Subject: Magee Preserve
Danville, California

RESPONSE TO PUBLIC COMMENT

RELOCATED STORM DRAIN OUTFALL ANALYSIS

Relocated Storm Drain Outfall Analysis Figure

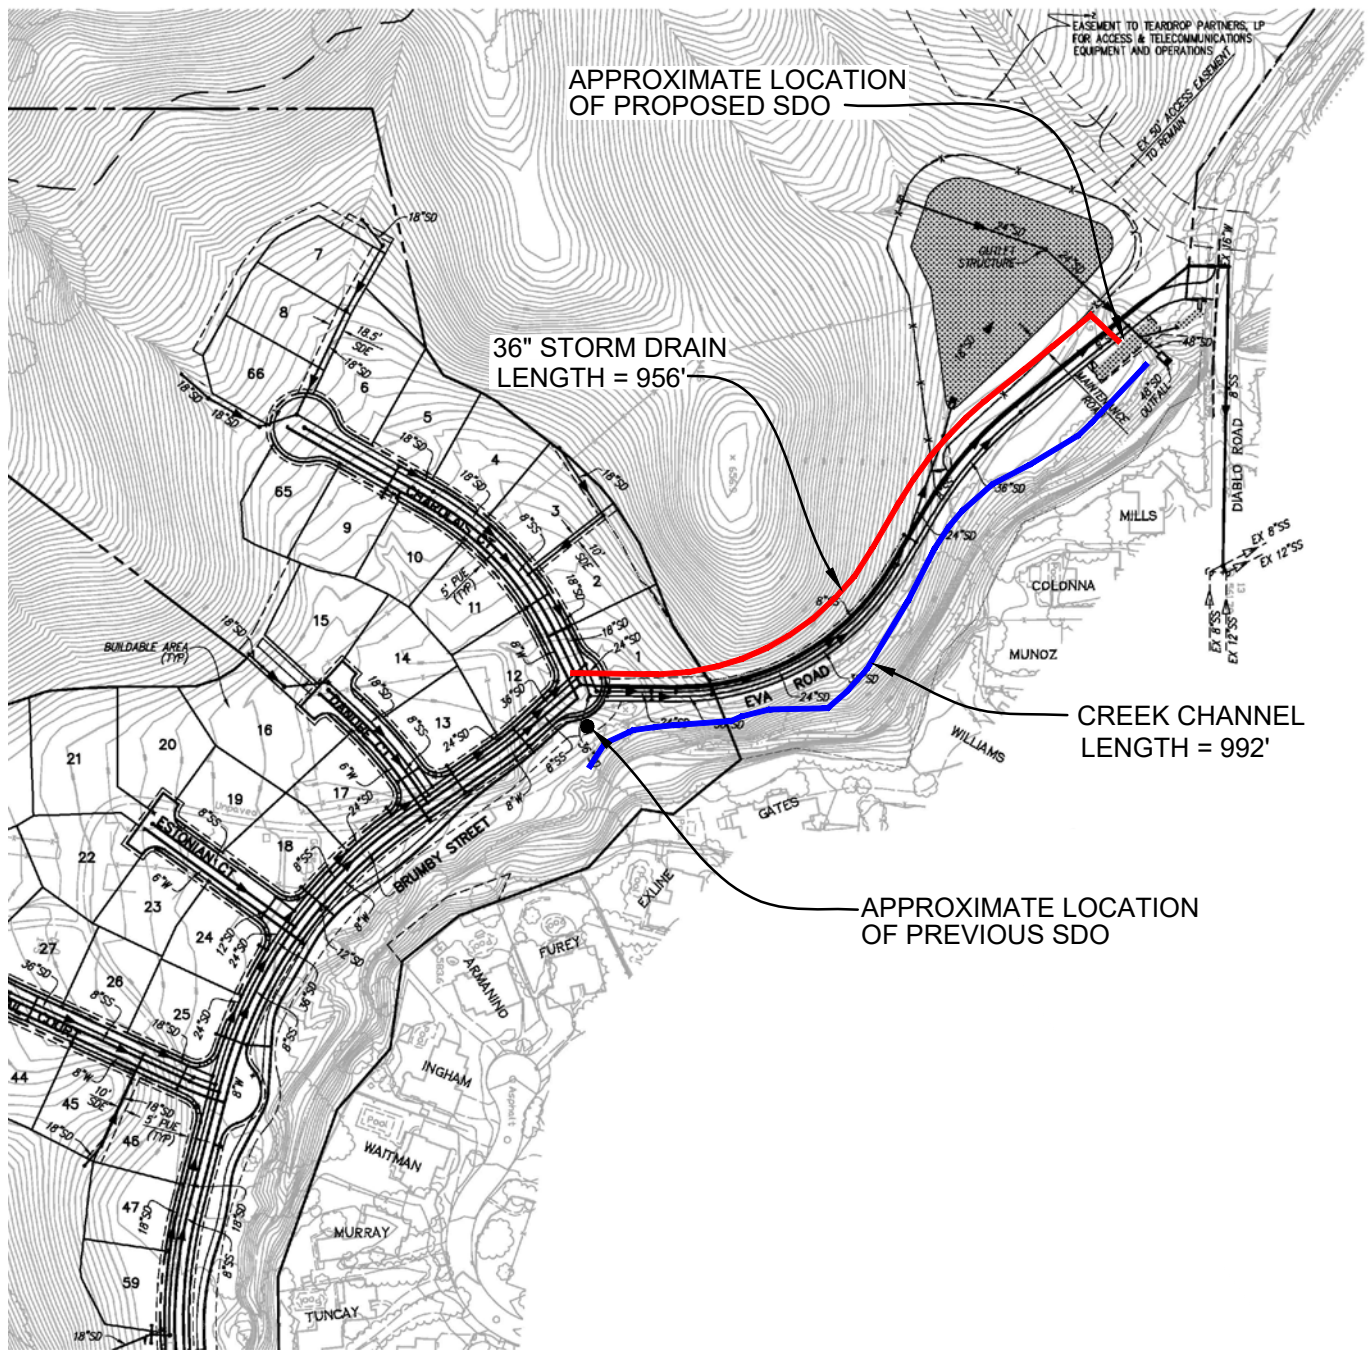
As requested, we are providing an analysis for a relocated storm drain outfall into the East Branch of Green Valley Creek at the proposed Magee Preserve redevelopment project. The storm drain outfall was originally located near the intersection of proposed Charolais Court and EVA Road on the original Improvement plans for the project prepared by Ruggeri-Jensen-Azar (Reference 2), but is proposed to be relocated approximately 1,000 feet downstream closer to the intersection of Diablo Road and proposed EVA Road. The relocated outfall would discharge in the same general location as the proposed project detention basin. The purpose of this analysis is to determine the effect of the storm drain outfall relocation on the timing of project discharges into the East Branch of Green Valley Creek. In Reference 1, we performed an analysis that indicated that timing of project stormwater discharges into the creek would not coincide with the timing of peak discharges from the Green Valley Creek watershed and, therefore, would not increase peak flow discharges downstream of the proposed project.

According to the civil engineer for the project, Ruggeri-Jensen-Azar, the maximum velocity in the storm drain pipe segment that originates approximately at the original outfall location and continues to the new outfall location, is approximately 10 feet/second (fps). As shown in Figure 1, the storm drain travel distance between the previous and proposed outfall is approximately 956 feet. Accordingly, the travel time of stormwater through the proposed pipe segment is estimated at approximately 1.6 minutes

With the proposed relocation of the storm drain outfall, we estimate that project stormwater from the proposed storm drain system will concentrate at the project detention basin outfall in the East Branch of Green Valley Creek approximately 0.6 minute sooner during a 10-year storm, as compared to the previously proposed outfall condition. This small time difference would have no effect on the timing of discharge or magnitude of peak flow at the relocated outfall in the East Branch of Green Valley Creek, which was previously calculated using the United States Army Corps of Engineers' Hydrologic Engineering Center Hydraulic Modeling System (HEC-HMS) software utilizing 15-minute time steps (Reference 1), since the difference in travel time is so small. It is therefore our professional opinion that the proposed storm drain outfall relocation will have a negligible effect on the timing of discharge or magnitude of peak flow in the East Branch of Green Valley Creek.
